EBEY'S LANDING HISTORIC PRESERVATION COMMISSION
ISLAND COUNTY COMMISSIONERS' HEARING ROOM (Room 102B)
1 NE 6th St., COUPEVILLE, WA
July 10, 2025

- **EBY-25-025:** R13115-285-3400; 975 Fort Casey Rd, Coupeville. Mossman – New SFR
- **EBY-25-023:** R13114-120-5030; 433 Wanamaker Rd, Coupeville. Wood – After-the-Fact Historic House Remodel

Ebey's Landing National Historical Reserve
Certificate of Appropriateness
Mossman
975 Fort Casey Road
EBY-25-025

SITE PLAN

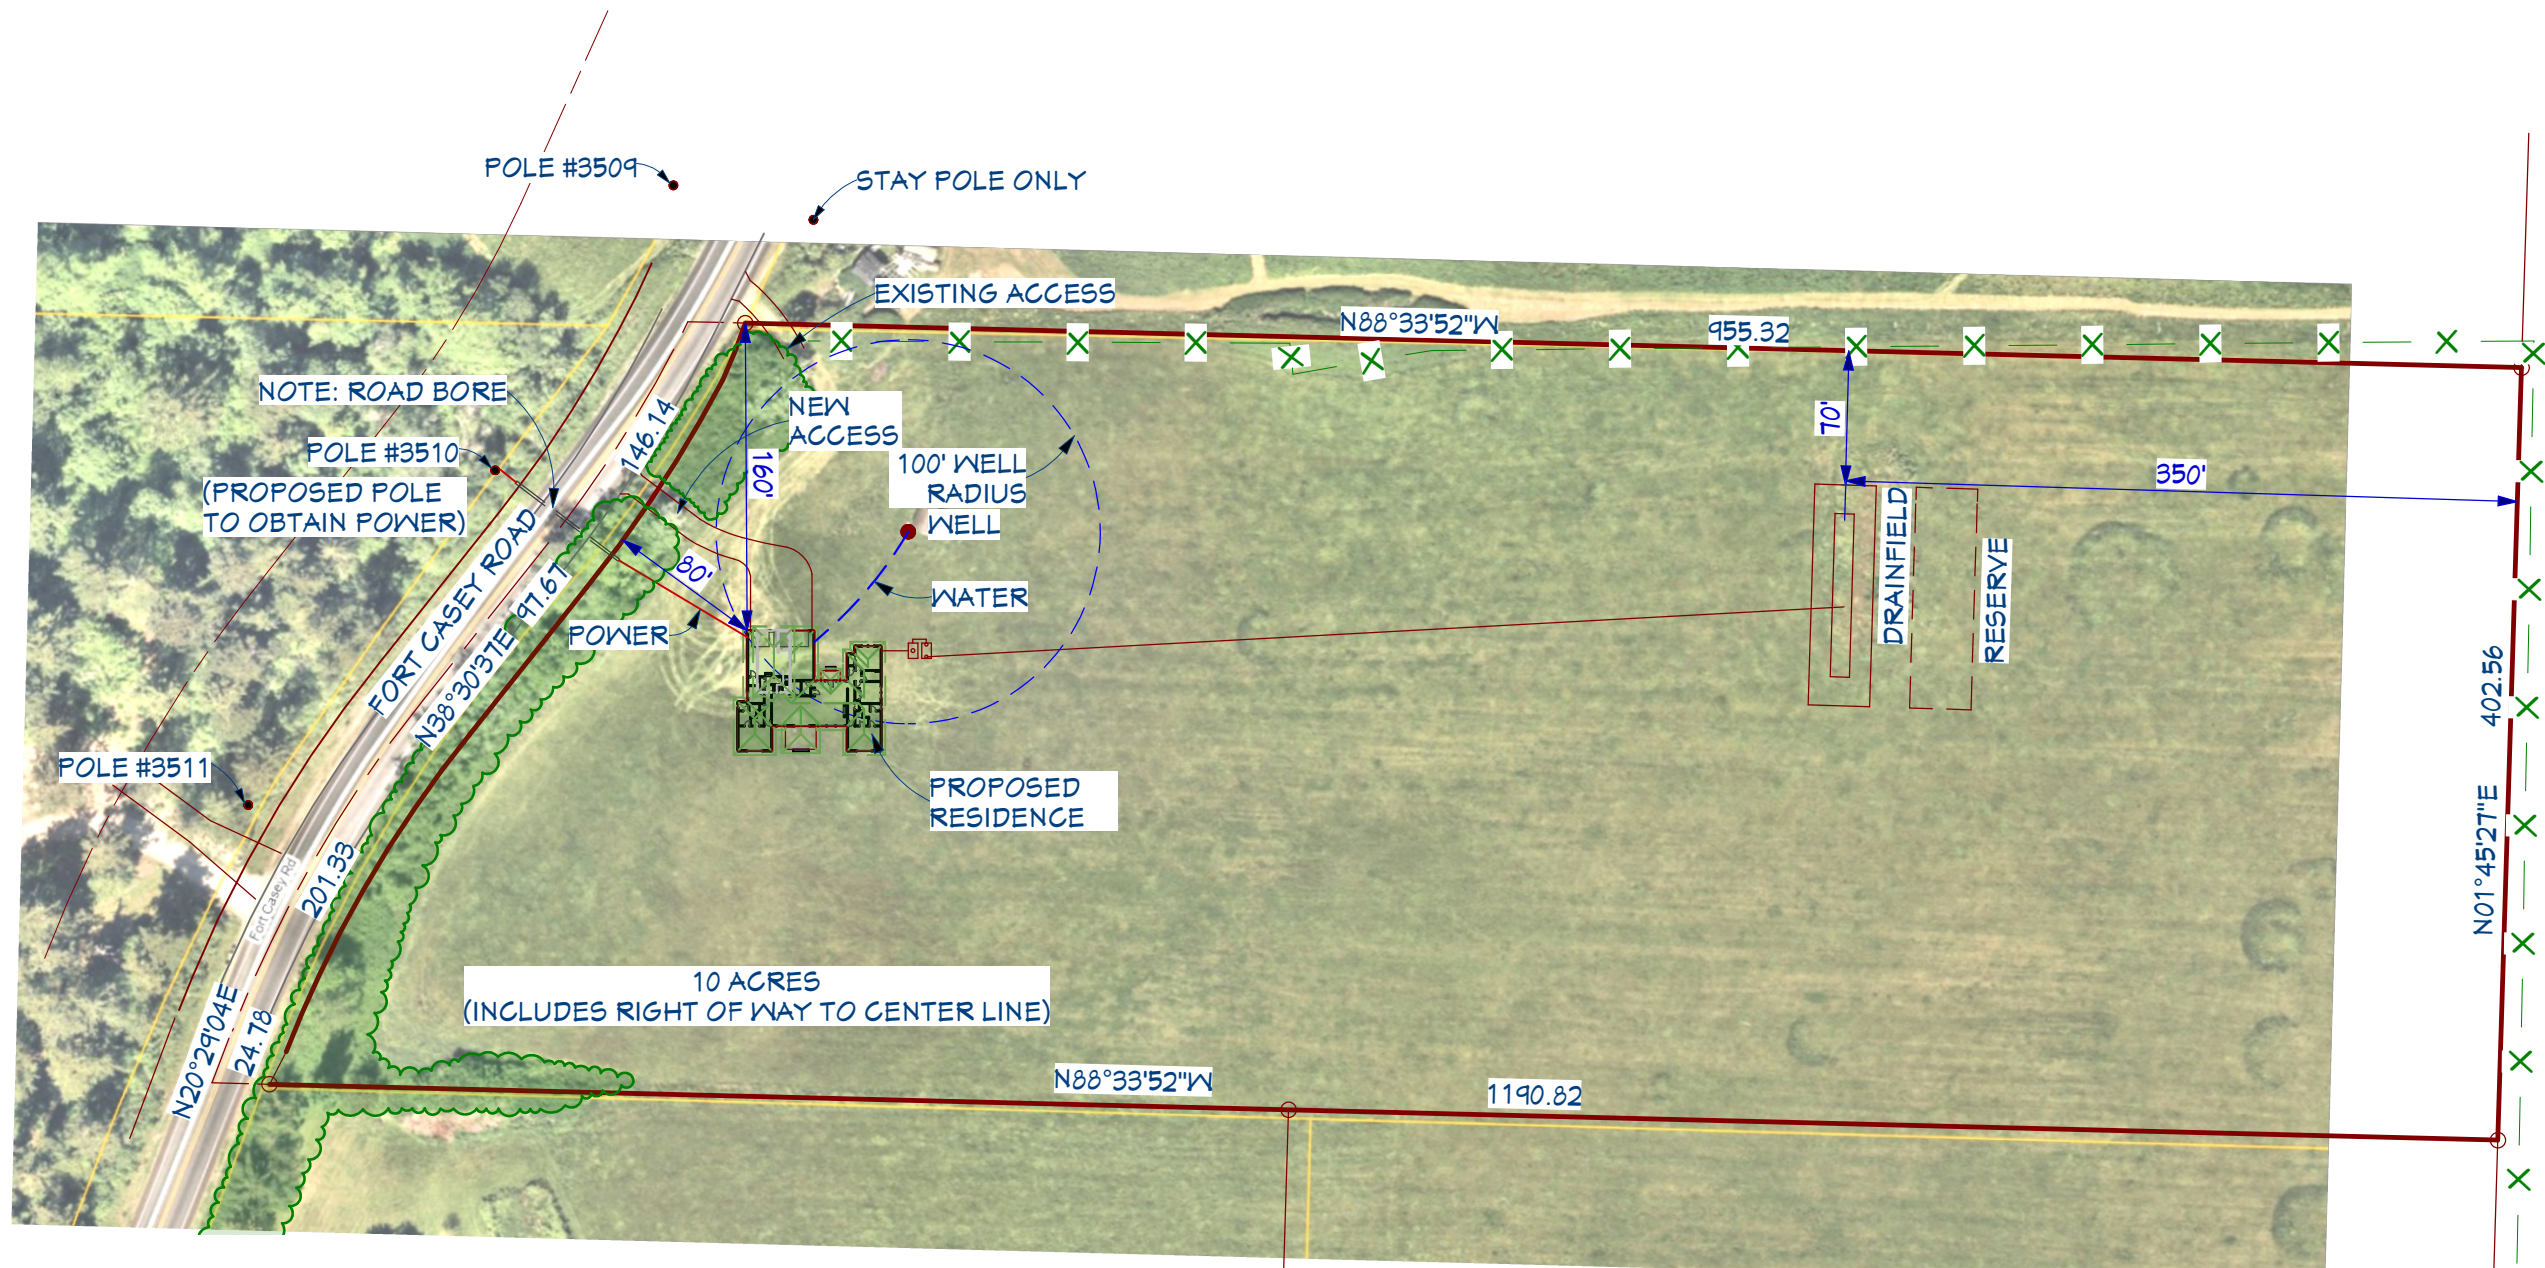
In conformance to the conservation easement and the Island County Code requirements on building in the Rural Agriculture Zone (ICC 17.03.090), the proposed house will be roughly 18 feet tall, significantly below the height maximum. The roof will also be made of Pabco composition shingles, which is non-reflective and can blend into the site’s setting. As for the large plantings to obscure the new house, the existing trees along Fort Casey Road serve as adequate screening of the parcel from the public view.

4.5.1.2	<p><i>Plan the site layout (including buildings, roads, and other elements) to preserve scenic vistas, historical patterns of development, natural and historic landscape features (such as hills, trees, ponds, hedgerows, woodlands, or open fields), and visual relationships.</i></p> <p>Visual landscape features of the setting include the open field, trees and vegetation along the road, and the slight change in elevation. The construction of the new house will preserve these patterns as the house will be built low to the ground, allowing the large field to remain as the primary characteristic of the parcel. The trees will need to be cleared for access to the parcel, and the applicant proposed to an approximate 12 foot wide driveway, which is wide enough for one car to safely enter and exit the property.</p>

4.6.4.15	<p><i>Do not locate garages, parking lots, or carports in front of the building. Screen surface parking lots with appropriate vegetation. Provide parking at the rear of the lot, when feasible, and screen parking from adjacent properties</i></p> <p>The garage will be closer to the road than the house, however, the trees and vegetation along Fort Casey Road will provide enough screening such that the garage will not be noticeable.</p>
----------	--

Existing Attic Floor Plan

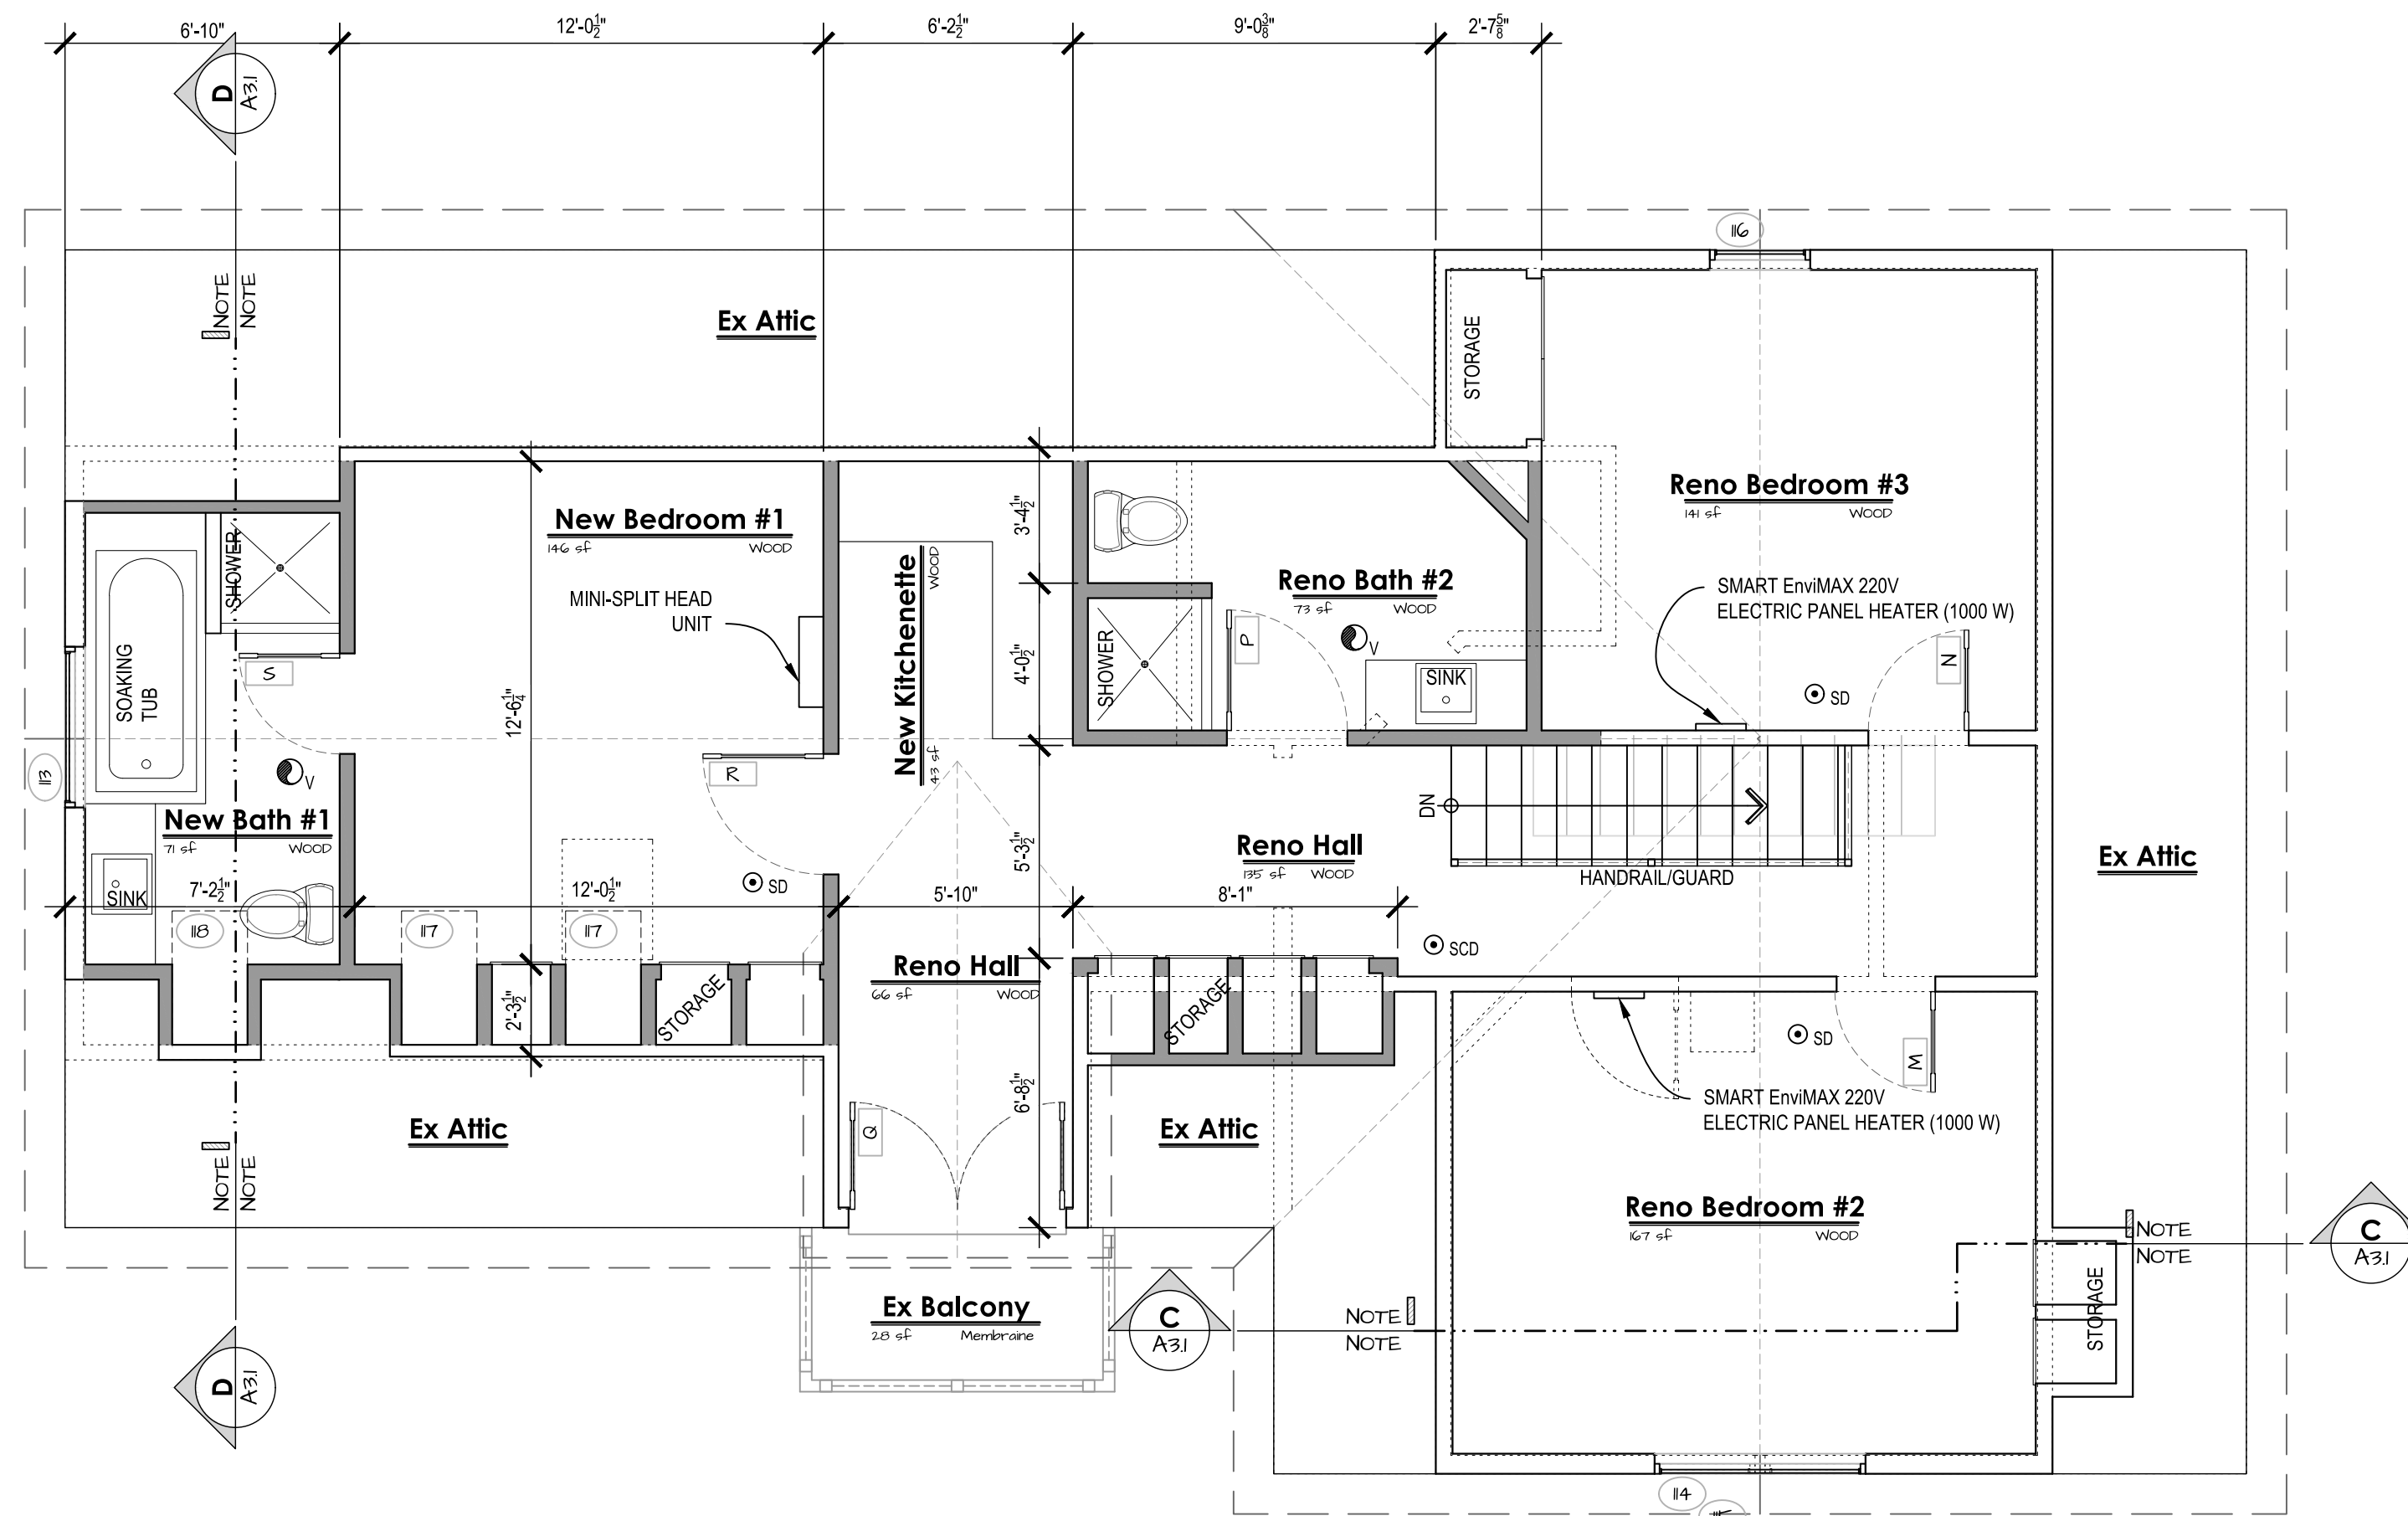
- **Addition of 3 skylights:** The introduction of three skylights represents non-historic intrusions onto the roof plane. These additions directly alter the roof and roof features and disrupt the overall visual character of the building. They introduce a modern element that is visually incongruous with the c. 1910 vernacular design, creating a jarring interruption in the historic roofline.

- **Replacement of 16 windows, including the change in dimensions of 10 of them; the addition of 2 new windows:** This represents a comprehensive and highly impactful alteration to the building's openings. Changing the dimensions of 10 windows fundamentally alters the rhythm or pattern of openings, which is a key character-defining aspect of the building's design and its ability to convey its significance. The addition of two entirely new windows further disrupts this original pattern and the building's design intent. The replacement of 16 windows, even if some dimensions were maintained, implies a significant loss of original fabric and potentially changes in critical elements such as muntin profiles, glass characteristics, or the type of wood used, all of which are vital to the window's historic character.

- **Replacement of 5 doors, including a change in dimensions; and the addition of 1 sidelight:** Similar to the window alterations, changing the dimensions of five doors directly alters the original openings and their rhythm or pattern. The addition of a sidelight, if not an original feature, introduces a non-historic element that impacts the original design and the trim and secondary features of the entryways.

- Skylights:
 - All three skylights must be removed. The roof must then be repaired to precisely match the original historic roofing material and configuration, ensuring that no visible impairment to the historic roof plane remains. This will restore the integrity of the roofline and eliminate the modern intrusion.

- materials, and glass characteristics, they should be replaced with accurate reproductions that adhere to the Secretary of the Interior's Standards.
 - For the 2 new windows added: These windows must be removed. The openings should be infilled with new construction that seamlessly matches the adjacent historic wall materials and finish, thereby restoring the original wall plane and fenestration pattern.

- For the 1 sidelight added: The sidelight must be removed. The opening should be infilled with new construction that matches the adjacent historic wall materials and finish, restoring the original doorway configuration.

From NE (2015)

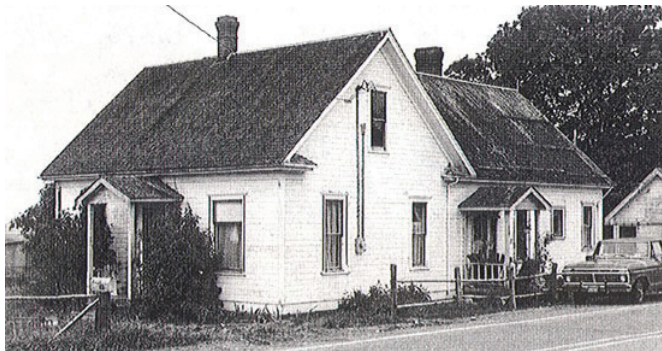
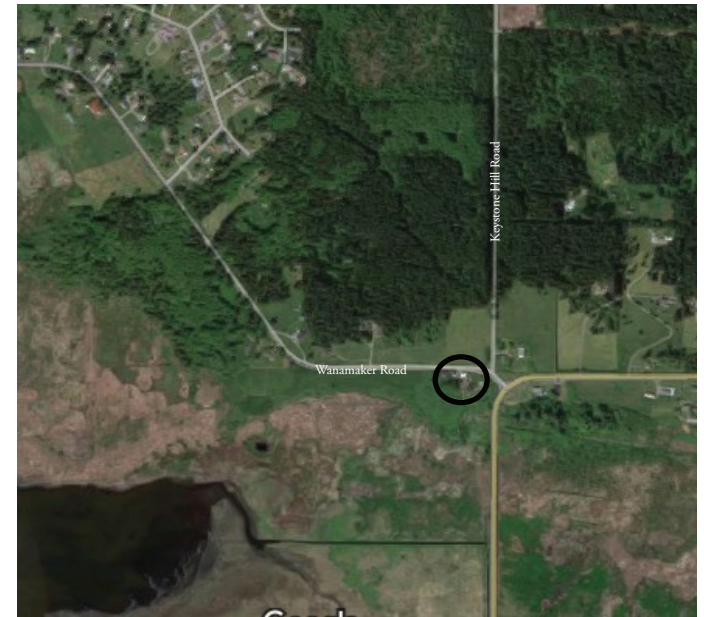
4.3.1.16	<i>Use shutters only when it is documented that shutters are original to the building.</i> The photos from the 1983 inventory images do not show any shutters on the house, and the applicant did not add any shutters to their remodel.
